DART SERVICE INSTRUCTION

**TO AMEND INSTALLATION INSTRUCTIONS D350-607-3 Rev.D,
INSTALLATION INSTRUCTIONS D350-607-4 Rev. C AND
INSTRUCTIONS FOR CONTINUED AIRWORTHINESS ICA-D350-607 REV. 6**

NO. 128801 MLS
15-01-28

A	NEW ISSUE	AJS	14.05.16
REV.	DESCRIPTION	BY	DATE
DESIGN	AJS	DART AEROSPACE LTD HAWKESBURY, ONTARIO, CANADA	
DRAWN	AJS		
CHECKED	N/A	DRAWING NO.	REV. A
MFG. APPR.	N/A	DSI 9699	SHEET 1 OF 2
APPROVED		TITLE	SCALE
DE APPR.		LUG REPLACEMENT	NTS
DATE	14.05.16	COPYRIGHT © 2014 BY DART AEROSPACE LTD THIS DOCUMENT IS PRIVATE AND CONFIDENTIAL AND IS SUPPLIED ON THE EXPRESS CONDITION THAT IT IS NOT TO BE USED FOR ANY PURPOSE OR COPIED OR COMMUNICATED TO ANY OTHER PERSON WITHOUT WRITTEN PERMISSION FROM DART AEROSPACE LTD.

FIGURE 1: INSTALLATION OF D4775-041 FWD STRUT

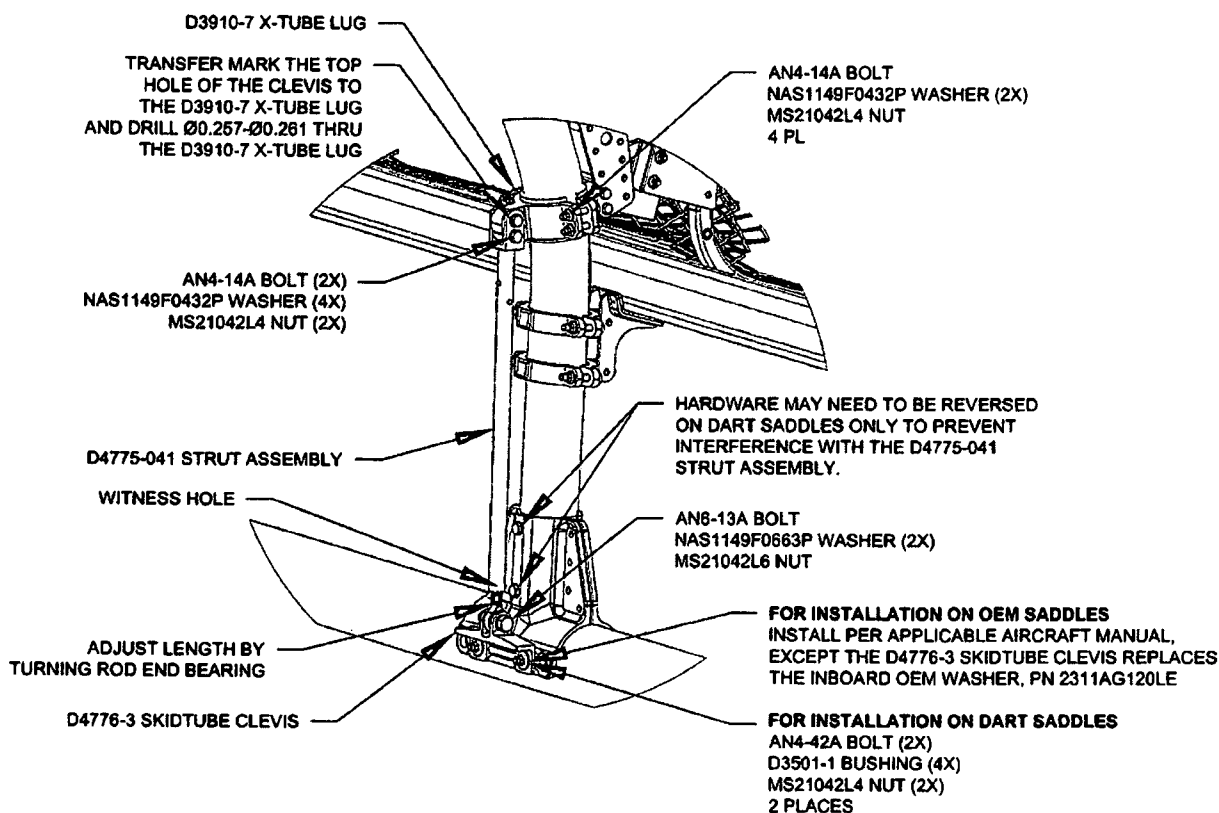
- 3.1 Substitute the Forward Lower D3910-5 X-Tube Lug with the D3910-7 X-Tube Lug as shown in Figure 1.
- 3.2 Install the forward D4775-041 Strut Assembly. Transfer mark from the upper hole on the clevis of the D4775-041 Strut Assembly to the D3910-7 X-tube Lug and drill thru the lug $\varnothing 0.257$ - $\varnothing 0.261$ as shown in Figure 1. Touch up chemical conversion coating per MIL-DTL-5541. Check the witness holes located at the bottom end of the D4775-041 Strut Assemblies to ensure that the thread from the rod end extends past the witness hole.
Torque MS21042L4/-4 nuts to 50-70 in-lbs (5.7-7.9 N-m). Torque MS21042L6/-6 nuts to 160-190 in-lbs (18.1-21.5 N-m).
- 3.3 Complete the installation in accordance with Installation Instructions D350-607-3 Rev. D or D350-607-4 Rev. C.
